## Addendum No. 2

Project: West Washington Advanced Manufacturing Lab Project No.: 1720.01

Subject: Addendum No. I January 25, 2018

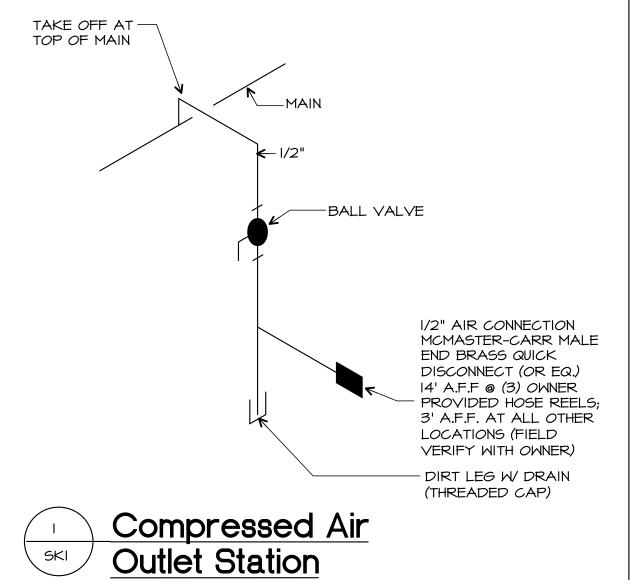
- I. Drawing A001 and A801: Delete items 11 and 24 in Addendum #1. See attached drawings SK2 and SK3 for revised widow elevation A2, and revised head detail at window A2.
- 2. Drawing P101:The typical compressed air outlet header pipe detail is revised and issued as drawing SK-1 attached to this addendum. The floor plan symbols showing check valves are incorrect and should be ball valves as indicated on drawing SK-1 (attached).
- 3. Drawing P101: Provide a thermostatic mixing valve for the eye wash station, Bradley S19-2100. Provide a 1" connection from the mixing valve to the emergency eyewash/shower.
- 4. Drawing P101: Fixture L-1 (in Healthcare Classroom CV101) is to be as follows:
